WRITTEN SUBMISSION OF ORAL CASE (ISH2)

M54-M6 LINK ROAD
M6 DIESEL SITE AT SAREDON

Project	M6 Diesel site at Saredon & M54-M6 link road		
Document Number	SAR-BWB-GEN-XX-RP-TR-0006	BWB Ref	NTH2442
Author	Simon Hilditch	Status	S2
Checked	Alan Darby	Revision	P1
Approved	Peter Selfe (M6 Diesel)	Date	08.01.2021

Figure 1: Path of HGVs from M6 southbound seeking Saredon filling station

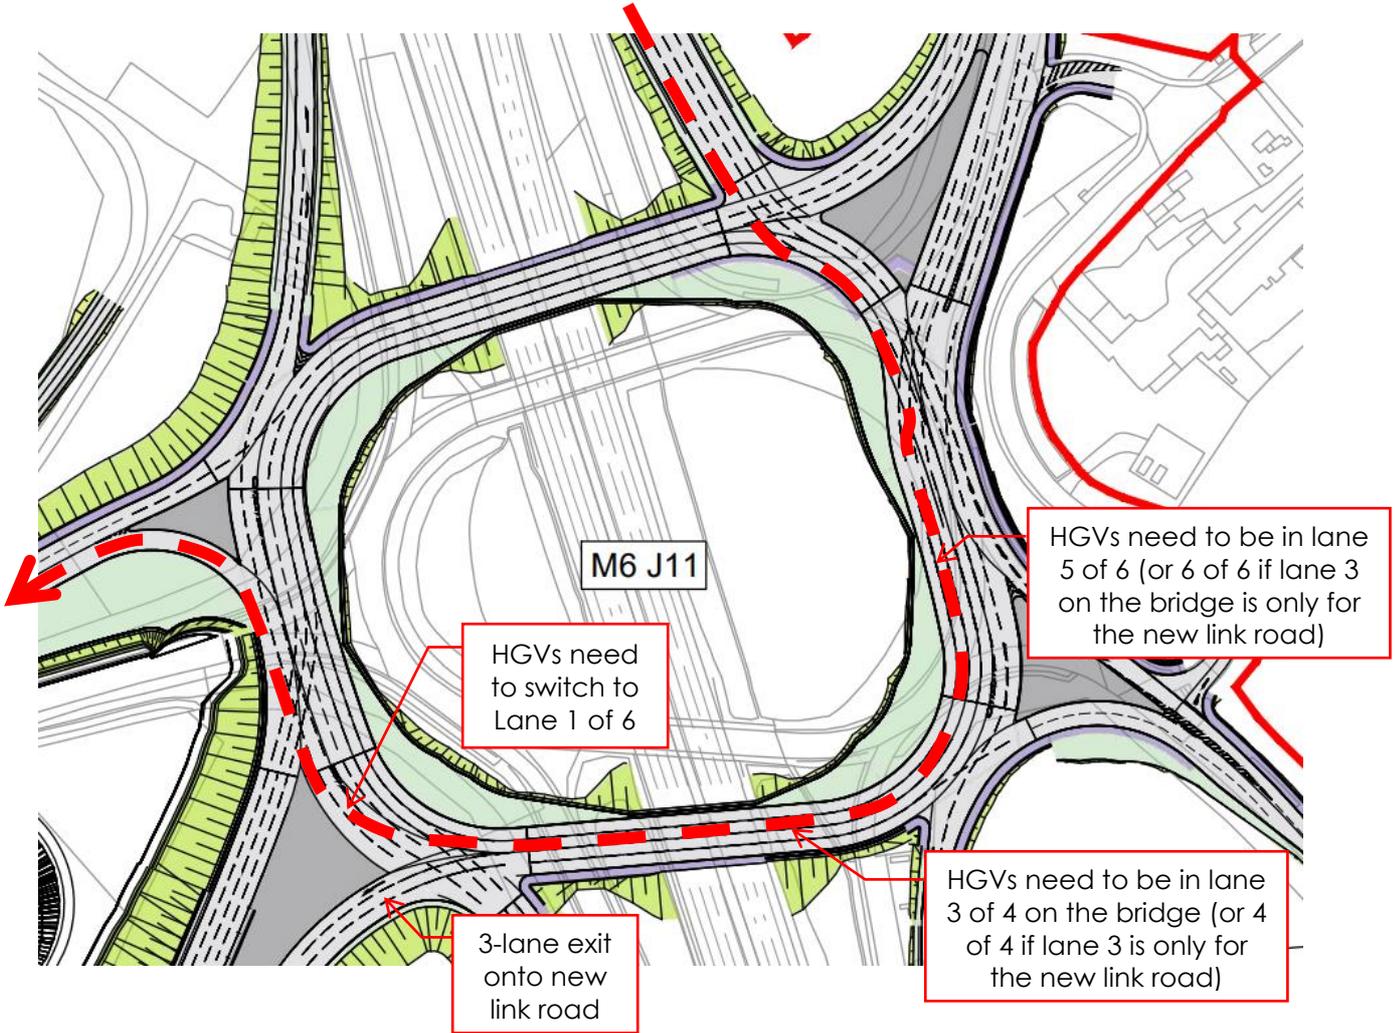
- 2.3 To emphasise how difficult it could be for HGV drivers seeking the M6 Diesel site navigating the signalised gyratory, we have shown on **Figure 1** below the vehicle path that an HGV from the M6 Southbound seeking the existing A460 exit has to take. The road layout used in this figure is extracted from the Applicant's general arrangement plan sheet 6 [AS-067].

- 2.4 Of particular concern is the requirement for HGVs to be in either lane 3 or 4 when heading across the south bridge (it is unclear from the Applicant's general arrangement plan whether vehicles proceeding to the existing A460 are to be in lane 3 or 4) and then immediately cut across four (or five) lanes to be in lane 1 before the traffic signal stop line at the entry for the new link road. We have shown on **Figures 2** and **3** below the potential safety implications of HGVs being in the incorrect on the southern bridge. Again the road layout is extracted from the Applicant's general arrangement plan sheet 6.

- 2.5 It is our view that the issues highlighted provide clear justification for signage to be provided to the M6 Diesel site to minimise the risk of significant numbers of large and heavy vehicles being in the incorrect lane when using the signalised gyratory. In particular the signage needs to clearly define how HGVs are expected to use the gyratory across the southern bridge and then take the exit for the existing A460.
